## Response to Anonymous Referee #1

The manuscript by Ortega-Becerril et al. investigates the effects of human-induced changes on the streams in semi-arid regions arguing that the changes to longitudinal profile and the lowered base level due to in-channel gravel mining and aquifer overexploitation lead to the intensification of geomorphic effects of flash floods. In this study, the authors compared two events occurred in the study catchment in 1973 and 2012 that were characterized by similar discharge but featured different flood dynamics. The manuscript is well written and easy to follow by the reader. In general, the analysis is sound and quite well documented but several points need to be better clarified. My main concern is related to the comparability between the two flash floods events and specifically on the flash floods characterization in terms of spatial and temporal rainfall evolution. A spatially-detailed representation of the rainstorms that caused flash floods, based on radar data, is not reported. This could not be a problem given the aims of the manuscript but this aspect should be at least mentioned along the text. Accordingly, there is a lot of literature on fla

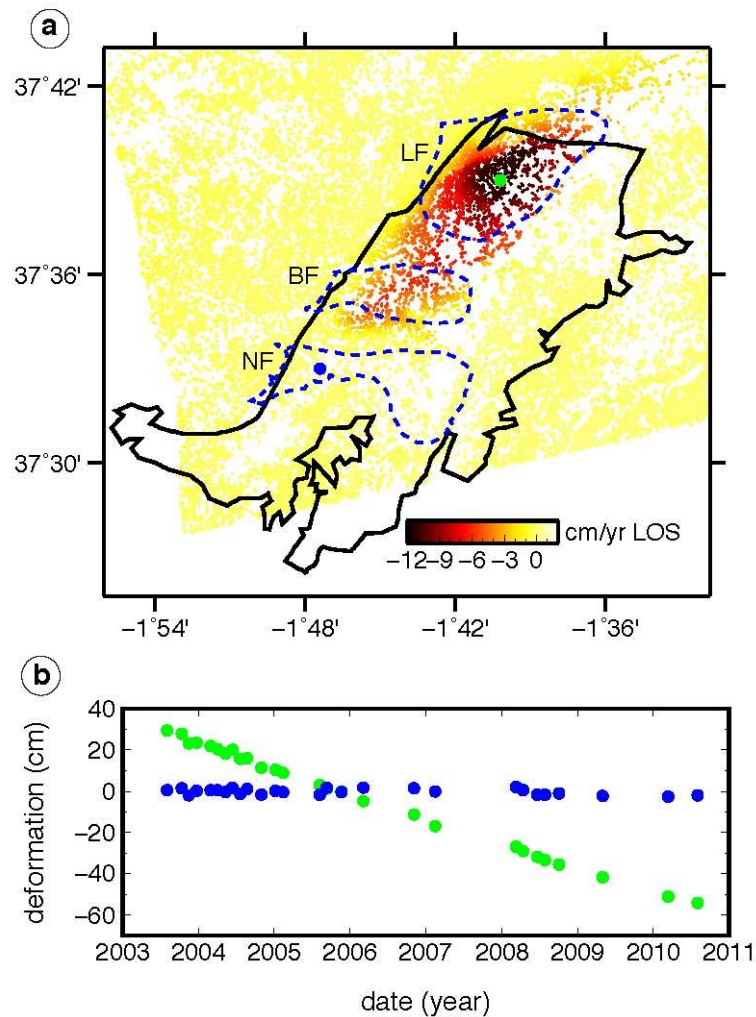
L173. I cannot see a clear correspondence between the percentages indicated in Fig 4d and the boundaries reported in Figure 4b. See specific comment on Figure 4.

Fig. 4. There are two different boundaries highlighted by black lines in reach 6. Which is the correct one?

I cannot see a clear correspondence between this percentages and the image above (e.g., Reach 2 changes seem lower or almost similar to those of reach 4). Please check carefully these data and please explain how did you calculate the changes (areal?). Did you consider also gravel quarries in the computation?

*See specific response in comment of Fig 4*

*Flood area in reach 2 in 1956 is  $0,25 \text{ Km}^2$  and  $0,14 \text{ m}^2$  in 2009, the difference is 43,2%. Flood area in reach 4 in 1956 is  $0,30 \text{ m}^2$  and  $0,28 \text{ m}^2$  in 2009, the difference is 7,4%. We think, the error comes from a change in right margin of the river that adds a portion of floodplain instead of decreasing all the section around. We modify the figure in order to clarify this aspect.*

*We include the Fig 4 revised:*
